UNITED STATES ENVIRONMENTAL PROTECTION AGENCY
REGION 8

MEMORANDUM

SUBJECT: Libby Asbestos Site, Operable Unit 3
Section 5.0 of the Phase III Sampling and Analysis Plan
Proposed Geotechnical Investigations

- **Attachment 1:** First revision, submitted to EPA in April 2009 by NewFields, an EPA contractor, with EPA internal review comments.
- **Attachment 2:** Additional revision of Section 5.3, Data Quality Objectives, submitted to EPA by NewFields on May 25, 2009.
- **Attachment 3:** Second revision, submitted to EPA in July 2010 by Formation Environmental (formerly NewFields).
- **Attachment 4:** EPA internal review comments on second revision.
- **Attachment 5:** Revised draft of Section 5.4, Sampling Design, transmitted by EPA to Remedium on December 16, 2010.

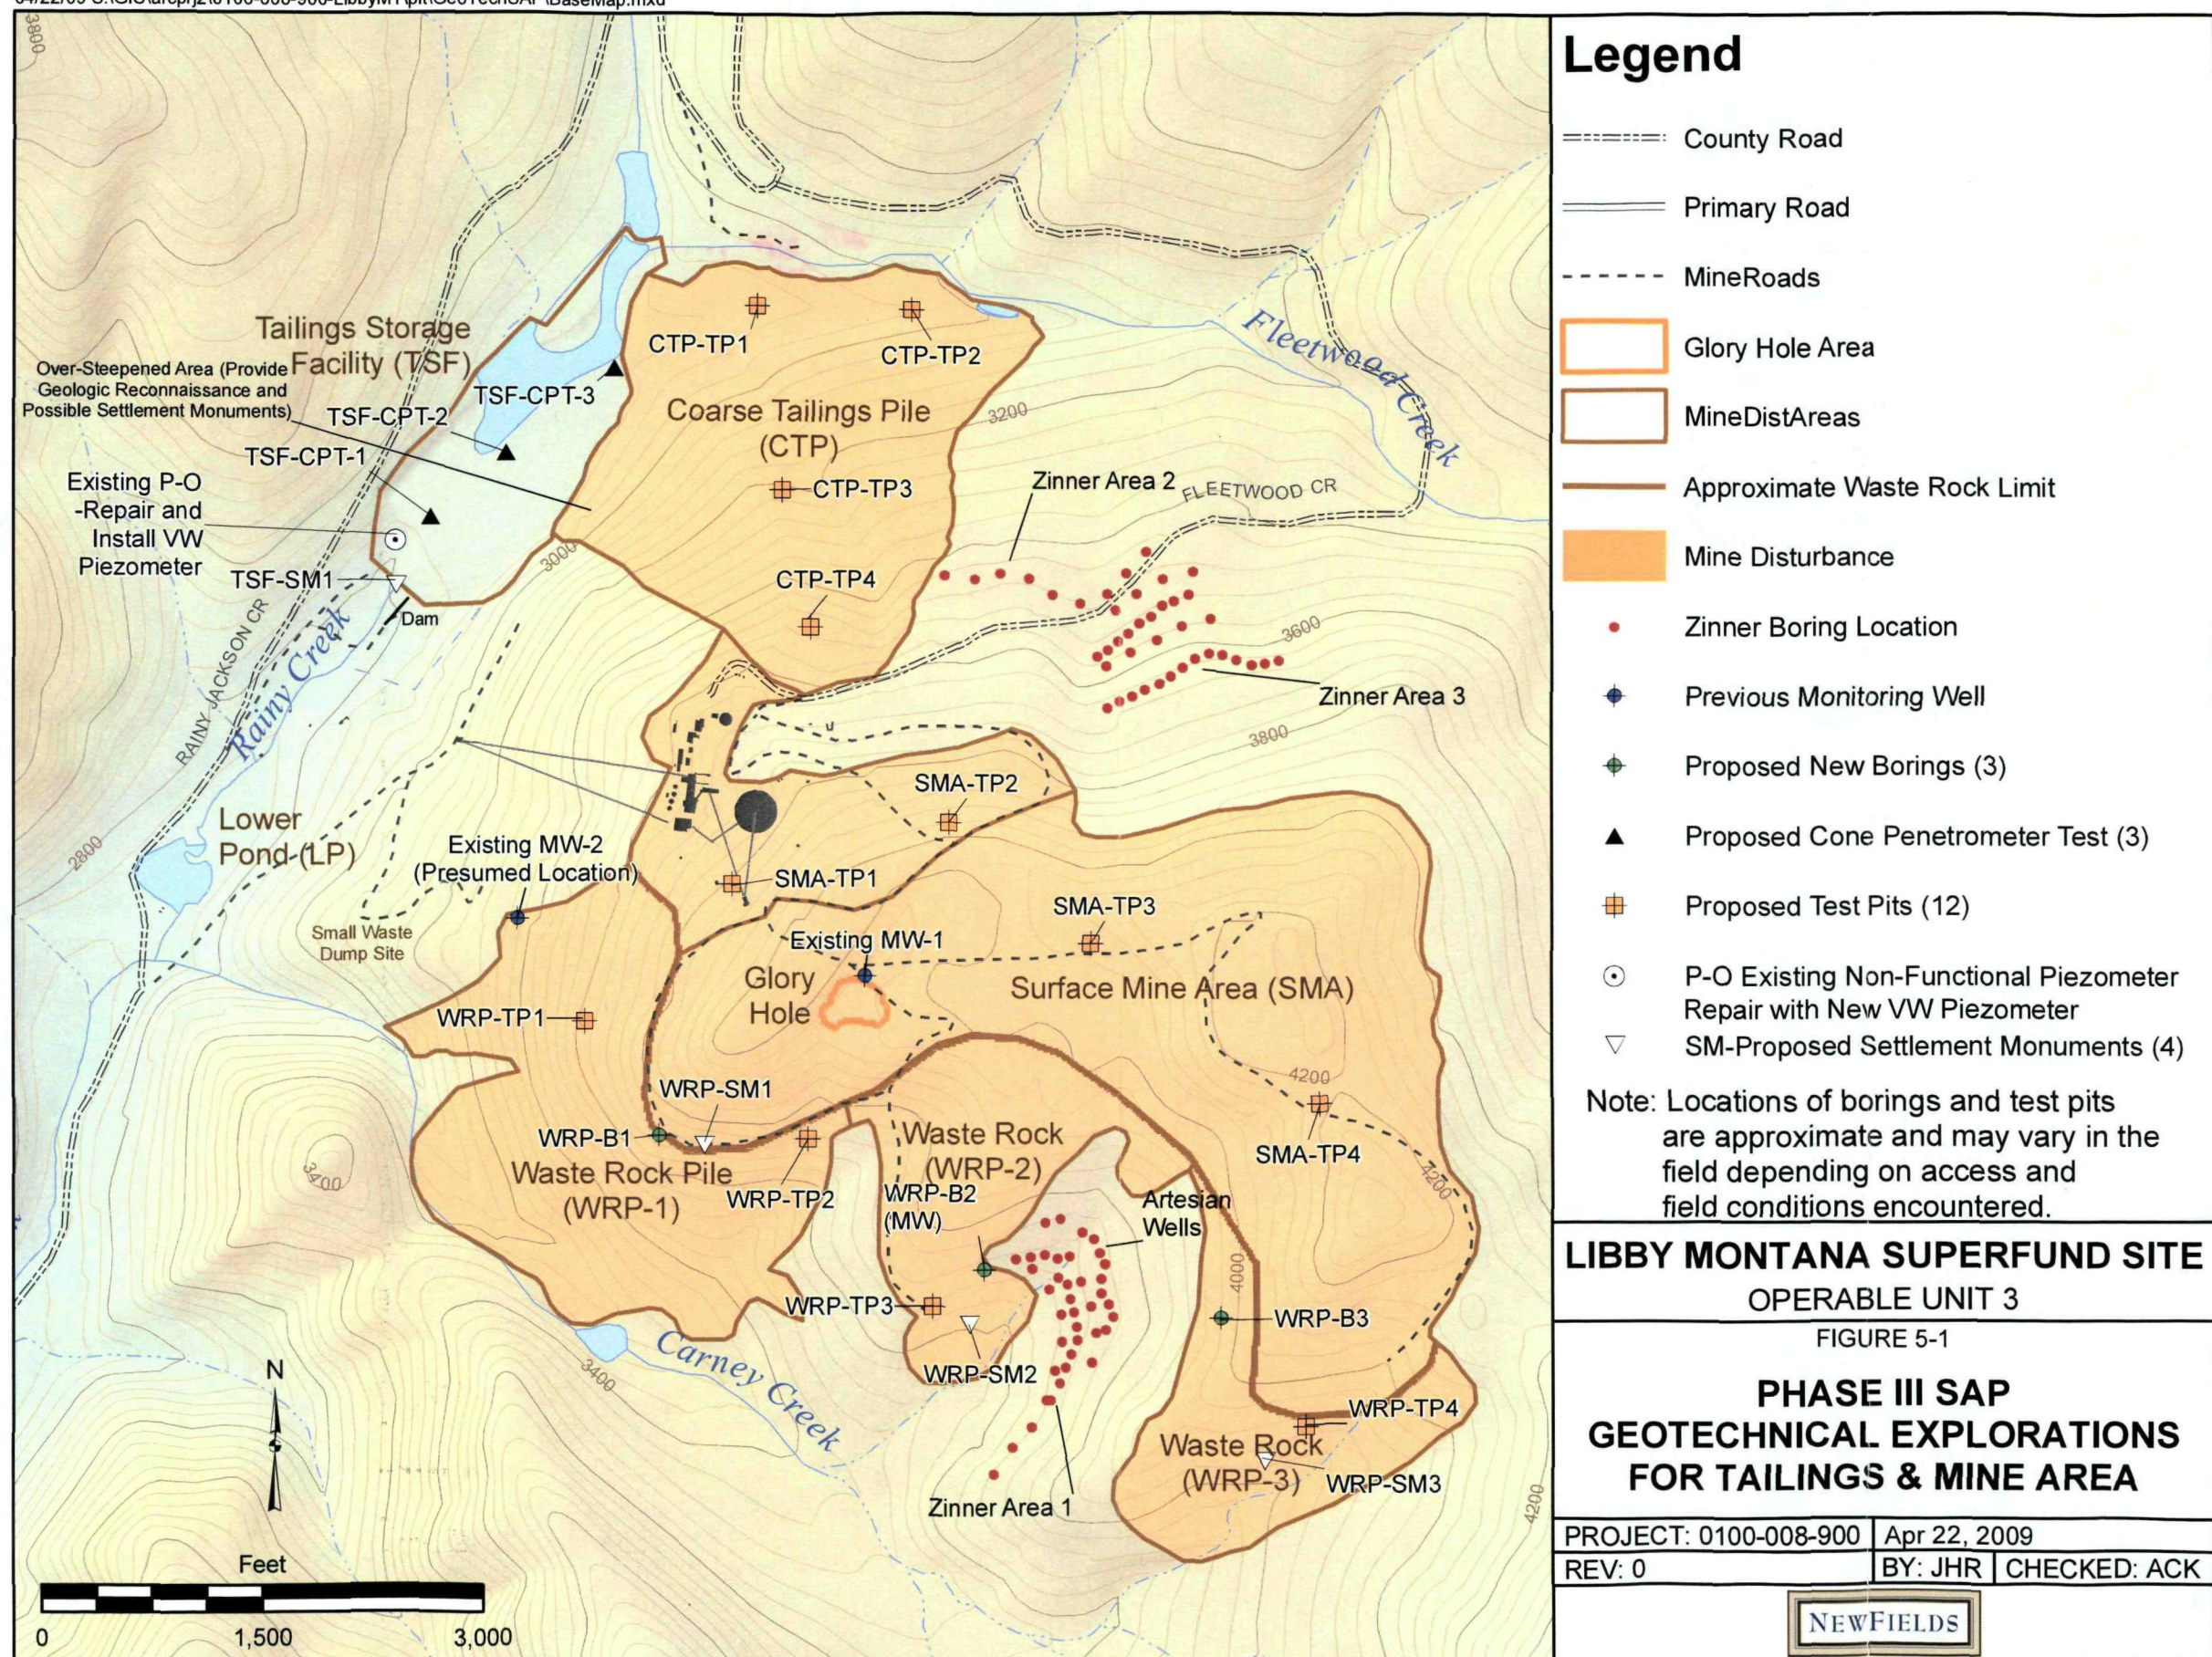
INDICATE ON FIGURE 5-1

~ INDICATE ON FIGURE 5-1 AS FORMER MILL AREA
AS PART OF RECLAMATION (?) (REF?)

FIGURE 5-2

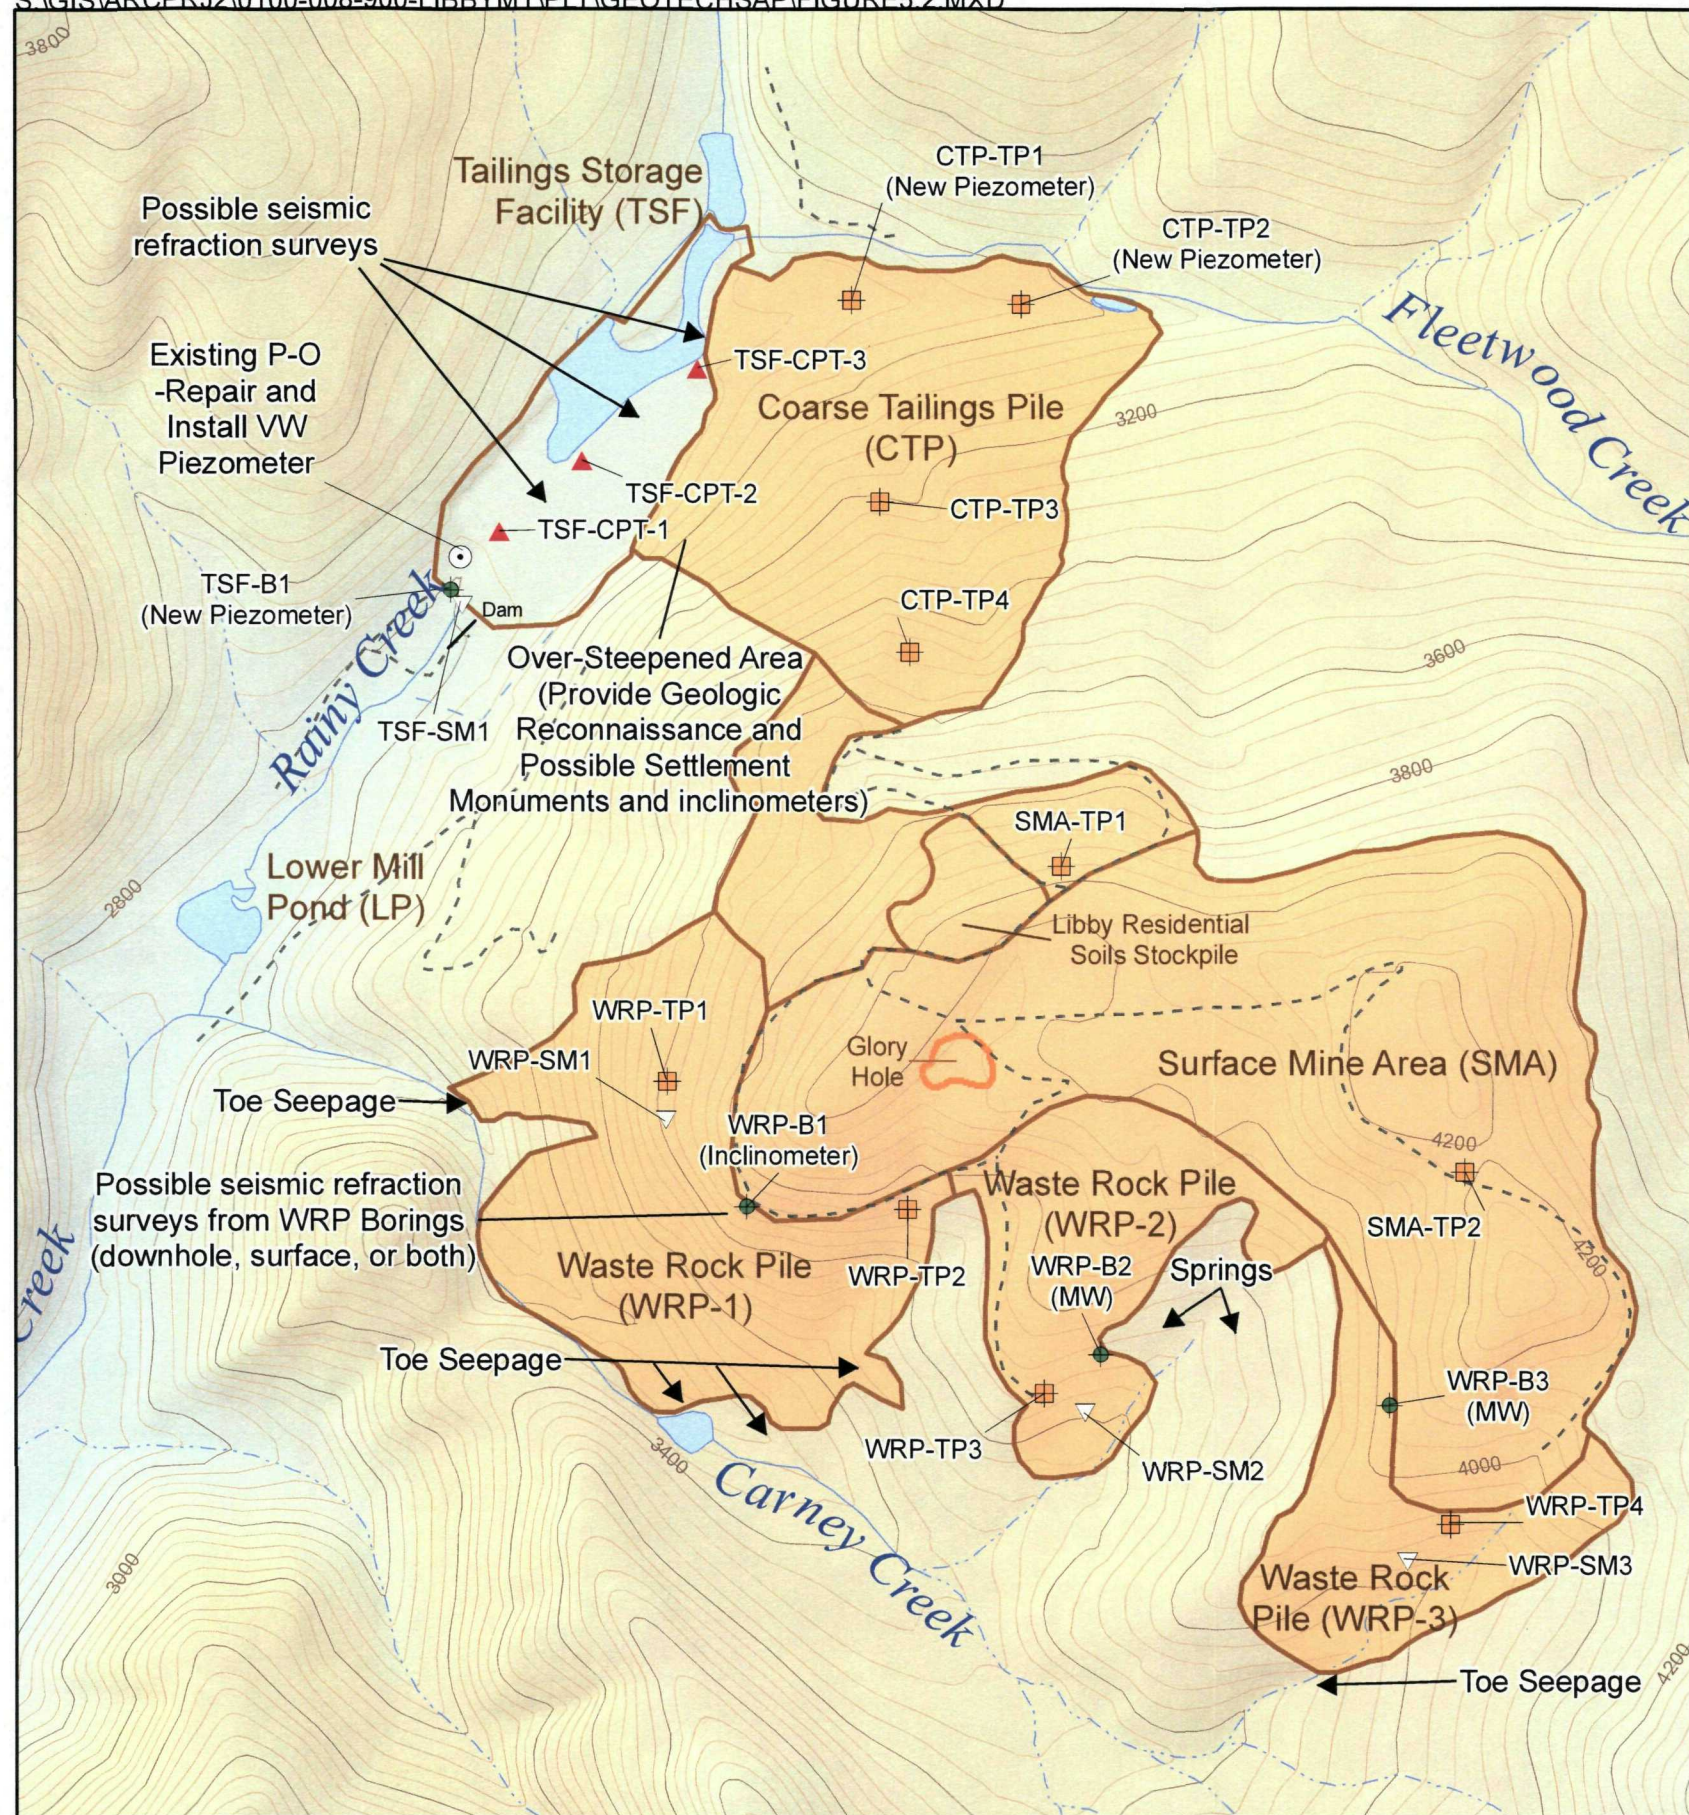
option to CPT - Geotechnical investigations for the Coarse Tailing Pile will require four test pits. Approximate locations of the test pits are shown on Figure 5-2. The location of the test pits may vary in the field depending upon accessibility. *- Give General Guidelines*
